Meeting: **Plan Commission**
Place: 1293 Washington Ave., Cedarburg
Date/Time: December 17, 2025 / 7:00PM*
Web Page: www.townofcedarburgwi.gov
Posted: December 12, 2025
**This meeting is also available remotely online. For remote access, email sjacoby@townofcedarburgwi.gov for information.*

**TOWN OF CEDARBURG
PLAN COMMISSION MEETING MINUTES
November 19, 2025**

PLAN COMMISSION MEETING MEMORANDUM

BACKGROUND INFORMATION	
Project Name	Gauthier Rezone/CSM/Pond
Applicant Name	Michael & Stacy Gauthier
Property Owner	Gauthier Properties at Covered Bridge, LLC Gauthier Properties at Wildwood, LLC Gauthier Properties at Wildwood II, LLC
Consulting Planner and/or Engineer Consulting Surveyor	Miller Engineers Scientists Chaput Land Surveys
Size of Parcel	132.39 acres combined for all five (5) parcels included in CSM (based on CSM acreage), additional 1-acre lot on Wildwood Drive
Existing Zoning	E-1 Estate, A-1 Agricultural, A-2 Prime Agricultural, R-2 Single Family Residential, and C-1 Conservancy
Requested Zoning	E-1 Estate (C-1 Conservancy to remain unchanged)
Abbreviated Legal	Sec. 10
Comprehensive Plan Designation	Rural Neighborhood – Countryside: Allows for E-1

DRAFT FOR REVIEW
POND PLAN & PROFILES

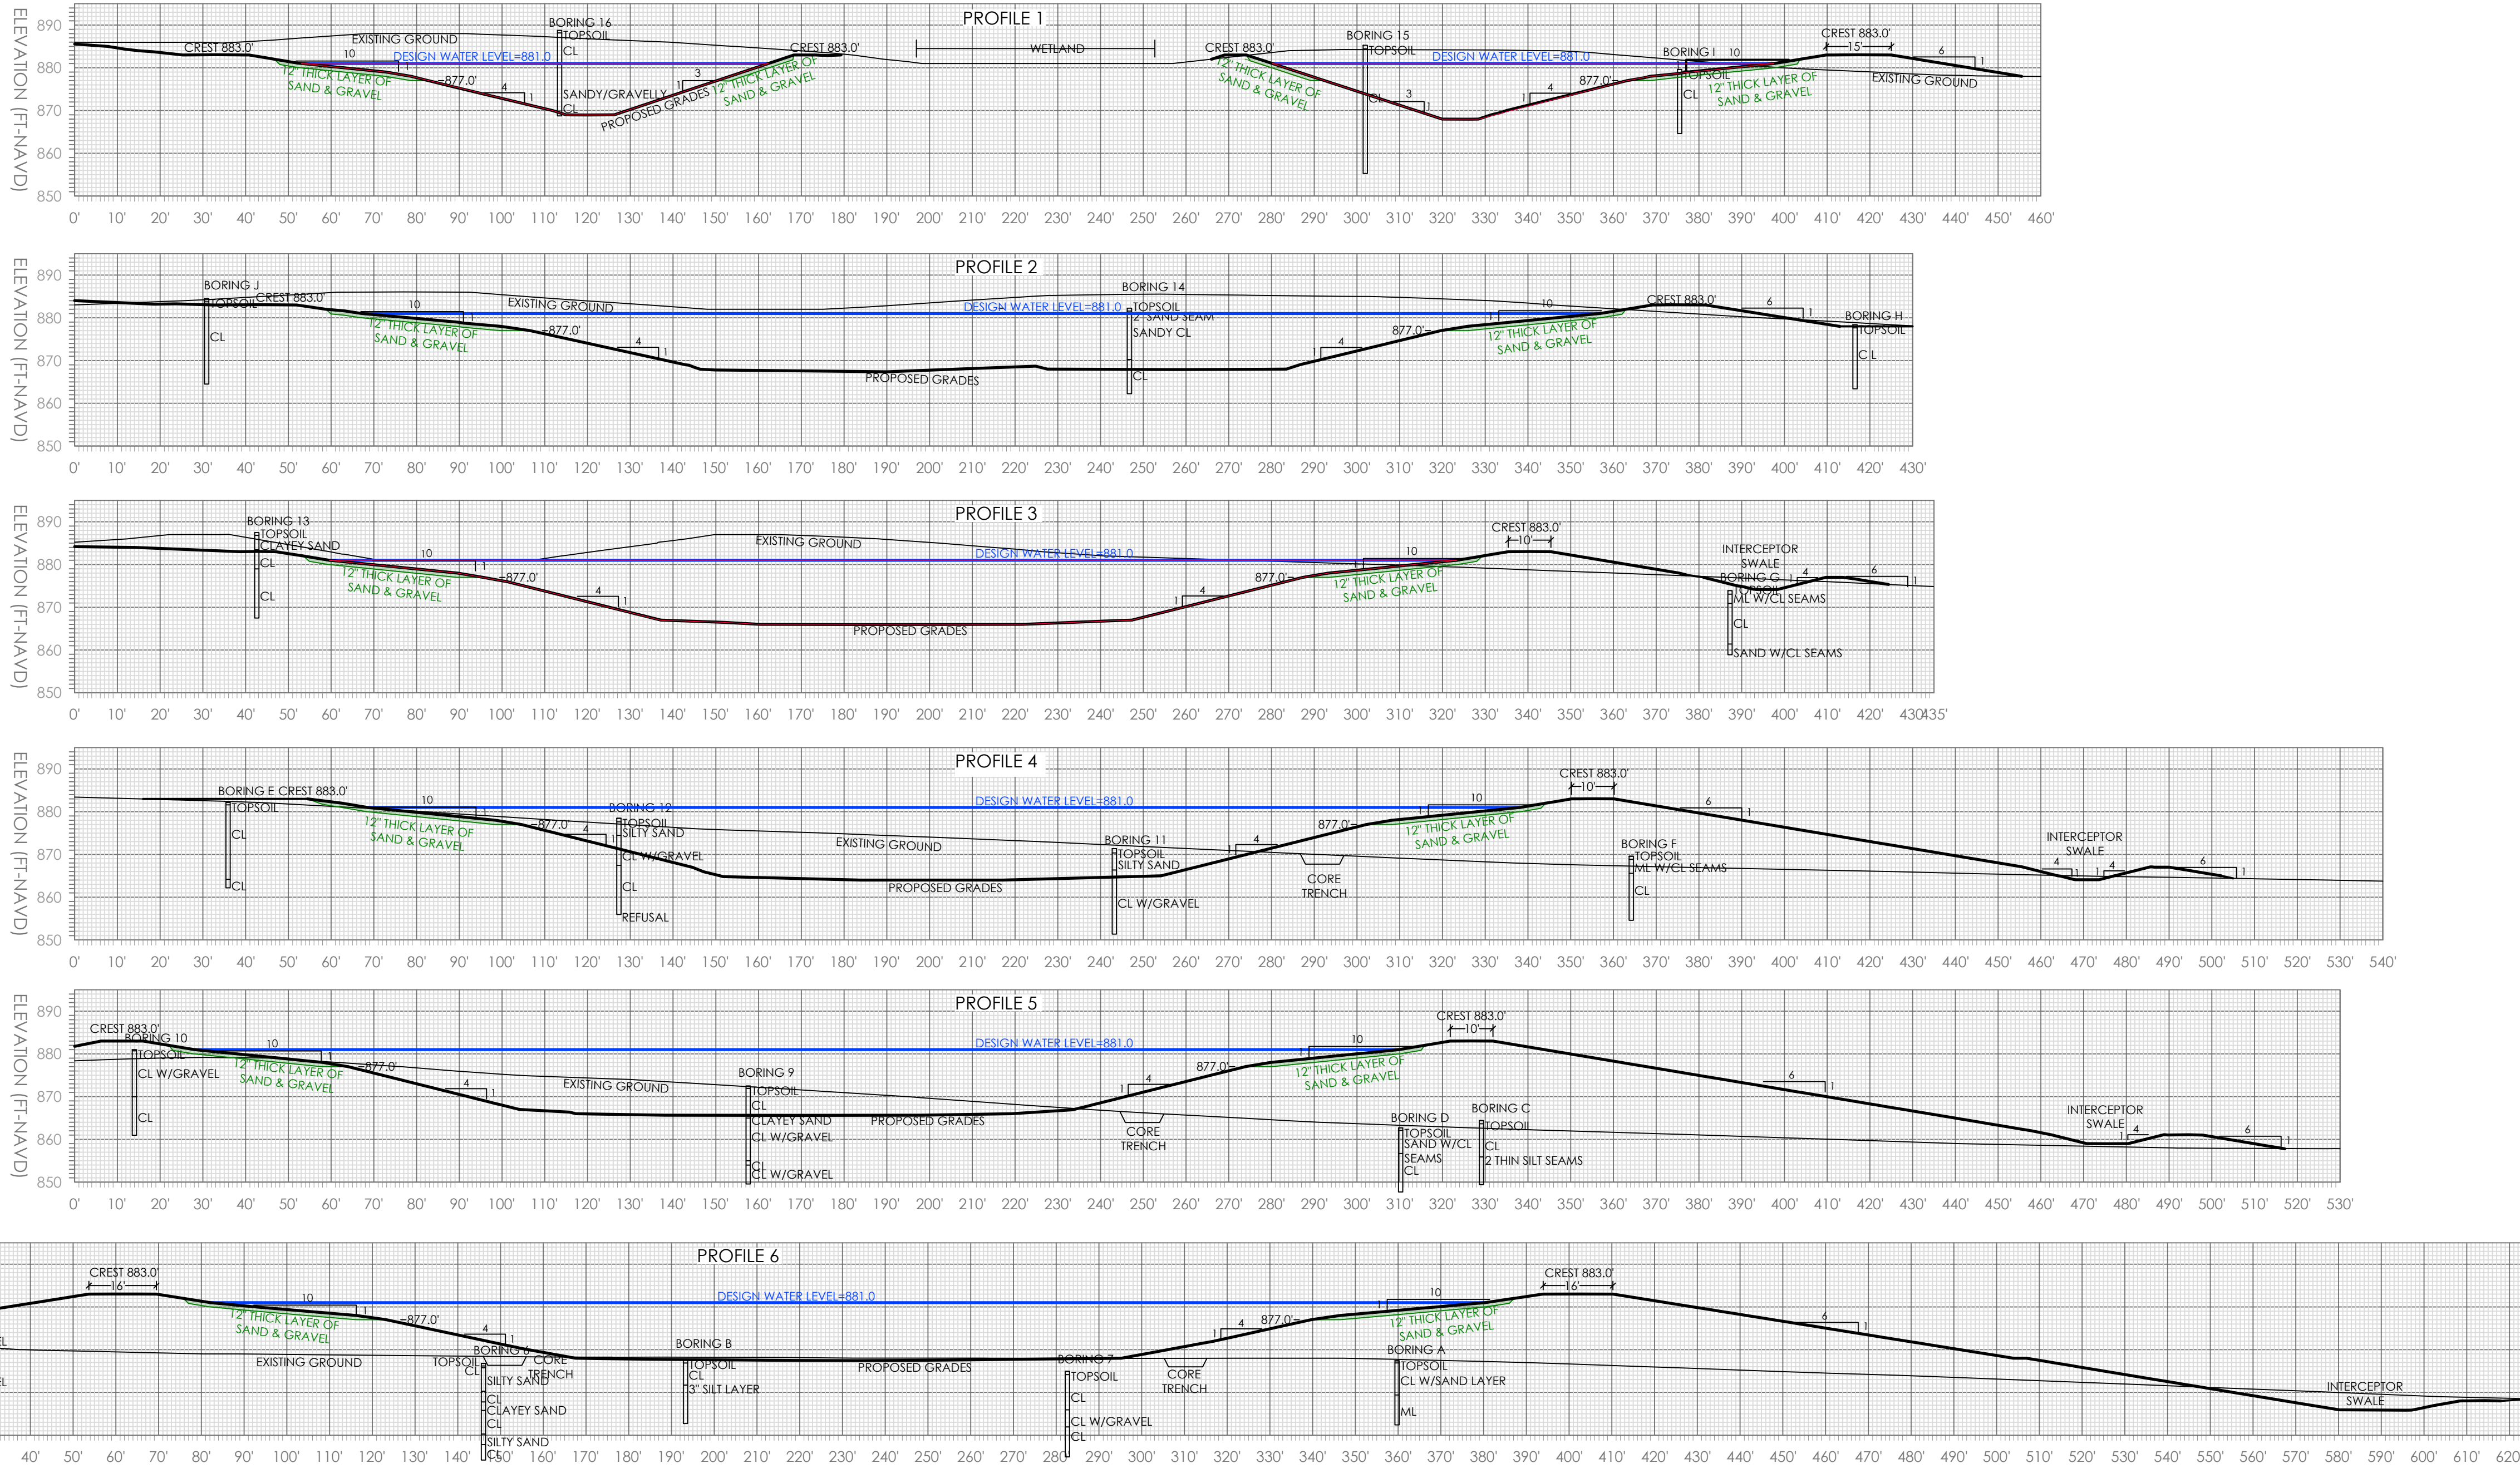
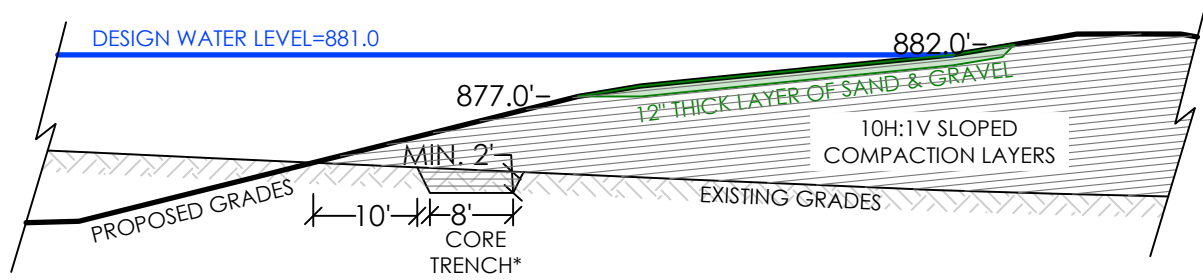
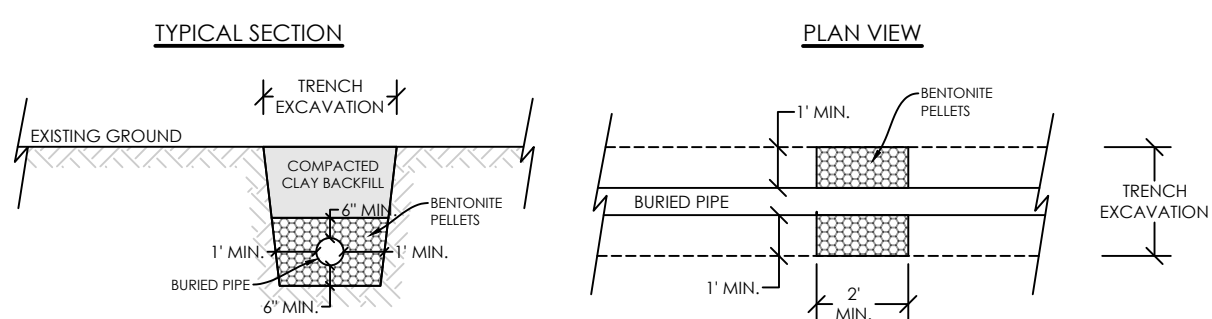
Memorandum requests that the elevation of the interceptor swale be at least 10 feet below the pond's water level. The northern portion of the pond (Cross Sections 1 and 2 on sheet 3 of the Plans) is an excavation into the existing high ground and is functionally an "at grade" impoundment in this location. Therefore, an interceptor swale at that location would have to be 5 feet lower than the adjacent grades at the property line. Even if the interceptor swale begins south of the northern portion that is effectively an at grade impoundment, the longitudinal slope of the swale would flatten below the design 1% which is not desirable due to decreasing flow capacity. At the south end of the pond (Cross Sections 5 & 6) where the embankment is highest, the bottom of the interceptor swale is at least 10 feet below the pond's water level as requested. Sections 3 and 4 are the unavoidable transition in between the north end of the pond excavated into high ground and the south end where the embankment is tallest, and the bottom of the interceptor swale at Cross Section 4 is 5 feet below the ponds water level.

raSmith Response:

make sure the updated plan shows a minimum depth of 3' on the backslope of the diversion berm. Lastly, at the sediment trap outlet, extend the diversion berm and swale to the outlet to ensure the flow path of this diversion swale.

Cedar Creek Near Cedarburg, WI - USGS-04086500

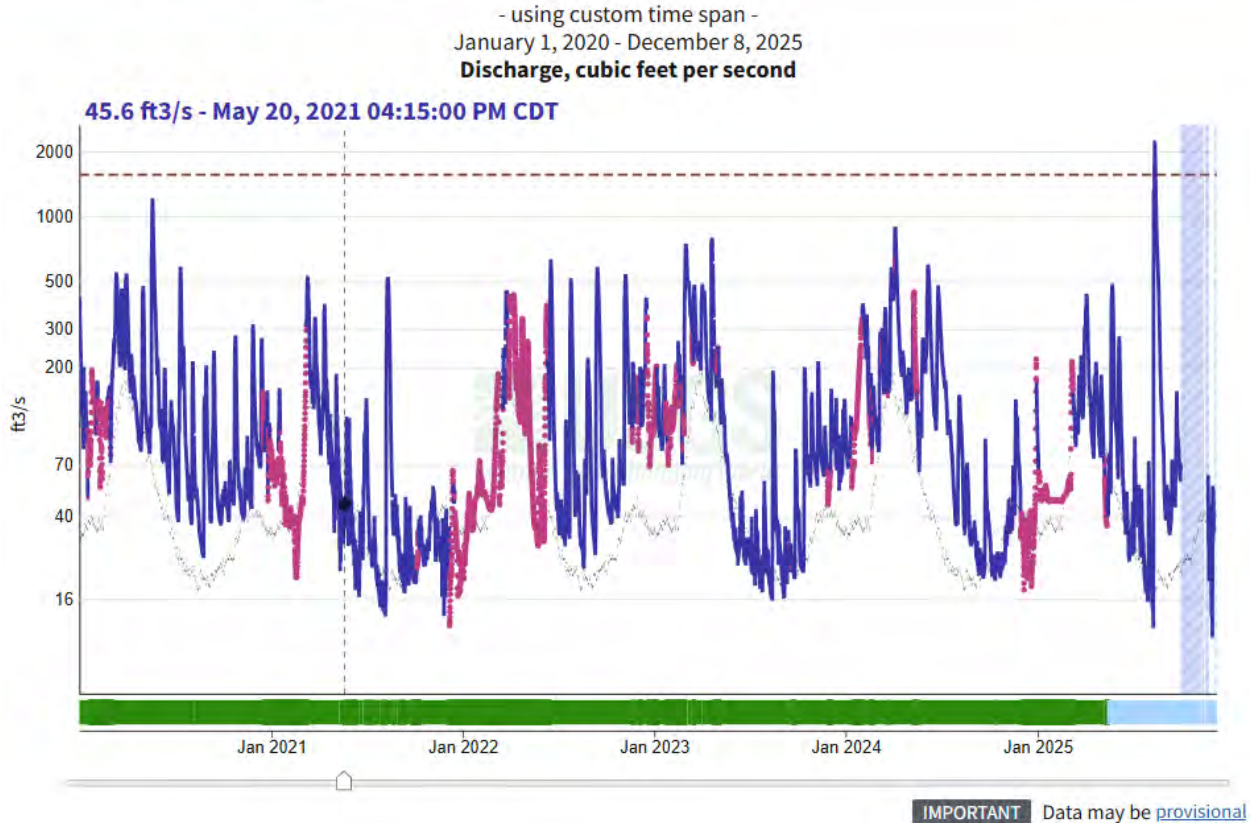
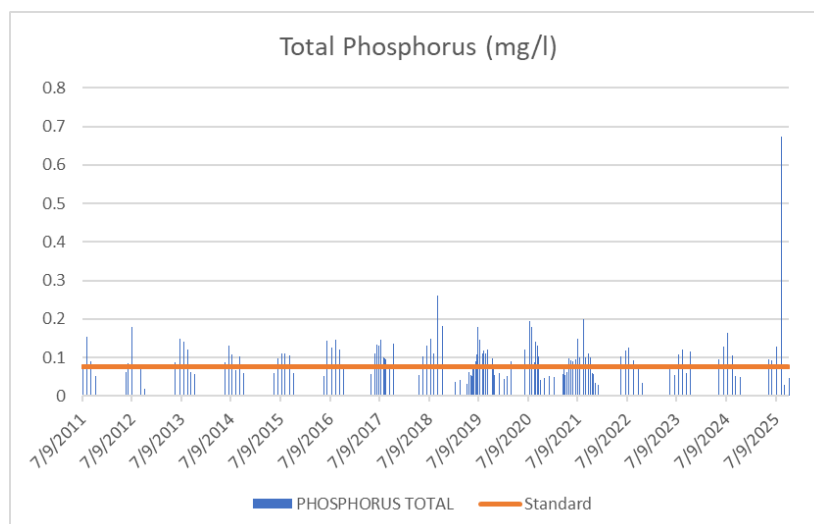
Taking the mean August flow of 35 cfs, (from 1930 to present), which is historically the lowest water levels of the year, that converts to around 22.6 million gallons per day (1 cfs is equal to around 646,317 gallons per day). The pump would be removing around 93,600 gallons per day from the creek if operating as designed, so that equates to around 0.4% of creek flows on a daily basis. At 10 cfs, typical of flows in late November and early December of this year, the water removed would be around 1.4% of water flows in this section of Cedar Creek. It's important to note that any drawdown of the shallow aquifer could also impact flows in this part of the river, so this could lead to additional flow reductions. In addition, there could be significant cumulative impacts from dewatering over an 8-9-month period that could impact the hyporheic zone, groundwater levels, the flow of the river and wetted perimeter.

Stream flows vary greatly on a daily, monthly, and annual basis based on a variety of conditions. Removing water from the creek during very low flow conditions over a period of weeks or months could harm aquatic life and strand freshwater mussels and other organisms in different parts of the creek as flows aren't evenly dispersed across the cross section of the stream. Shoreline areas are generally less deep or shallower (especially on an inner river bend as is the proposed pumping location), and it's fairly normal for streams to shrink in width or wetted area during summer and fall months. The pipe would likely have to be closer to shore to not interfere with navigation and could have a significant seasonal impact on the stream biota. It's difficult to fully analyze the impacts on the stream of this water diversion without knowing how long the pump would run and when, during which months, at what flow/stage levels, etc. A more detailed hydrologic and hydraulic analysis should be conducted for this project before the Town considers approval.
